**AGENDA**  
**SPECIAL MEETING OF THE AMES CITY COUNCIL**  
**COUNCIL CHAMBERS - CITY HALL**  
**JULY 30, 2012**

# **Ames Intermodal Project Cast in Place Concrete Stair Repair Proposal**

**July 27, 2012**

### **Structural Concerns**

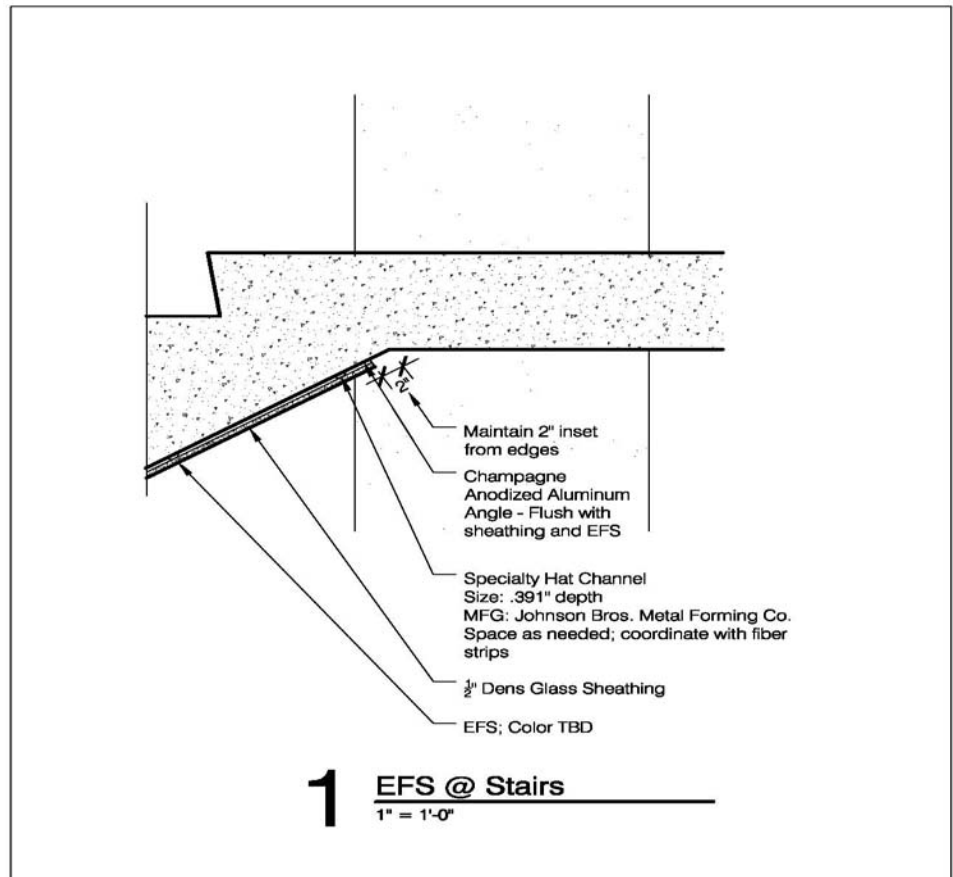
While walking punchlist Neumann Monson noticed cracks at the center span of the bottom of the elevated cast in place concrete stairs. Neumann Monson then proceeded to have Terracon conduct a scan of the stairs with ground penetrating radar in order to determine if the concrete reinforcing was installed correctly. The results are in the attached report entitled **Exhibit A**. In short it was determined that the reinforcing sizing was correct, however the bottom mat of steel consisting of #6 bars at 9" o.c. in the long direction and #4 bars in the short direction had moved up vertically, particularly at the middle of the span. It is assumed that the bars were installed in the correct position initially as they were inspected by Team Services prior and during the pour.

After notification by Neumann Monson, Weitz engineered a temporary shoring detail for the stairs and conducted destructive testing (removed a small area of concrete adjacent to one of the cracks) to confirm Terracon's findings. Weitz did this and confirmed Terracon's findings.

At that time Neumann Monson instructed Weitz to propose possible solutions to resolve the issue. A series of solutions has been discussed including removing the curtainwall and completely rebuilding the stair, adding supplemental structural steel members to support the stairs, and lastly, to utilize carbon fiber reinforcing.

After meeting with representatives of ISU and Cy Ride, Weitz is proposing the use of fiber reinforced carbon at the bottom of the stairs. The fiber reinforcement is laminated with an epoxy coating to adhere it to the bottom of the stairs. This reinforcing is designed to provide the same structural design capacity as the bottom mat of reinforcing that moved up vertically in the concrete. A Sika or a BASF system would be used for this. Both systems have been used extensively for structural repairs of bridge beams, bridge columns, and other cast in place concrete structures. Weitz would assume design responsibility for this repair and will specify the quantity, arrangement, and layout of the carbon fiber.

The repair would include jacking the stairs back to their original position using our shoring system. Then underside surface of the stairs where the carbon fiber is applied is ground down as much as an 1/8" of an inch to provide a clean, fresh surface to adhere the carbon fiber to. The carbon fiber is then applied in a bed of epoxy resin that fully adheres it to the underside of the stairs. The carbon fiber would then be covered in flame/ smoke retardant fire rated coating, Topcoat FRL is the name of this product and both the Sika and BASF products are compatible
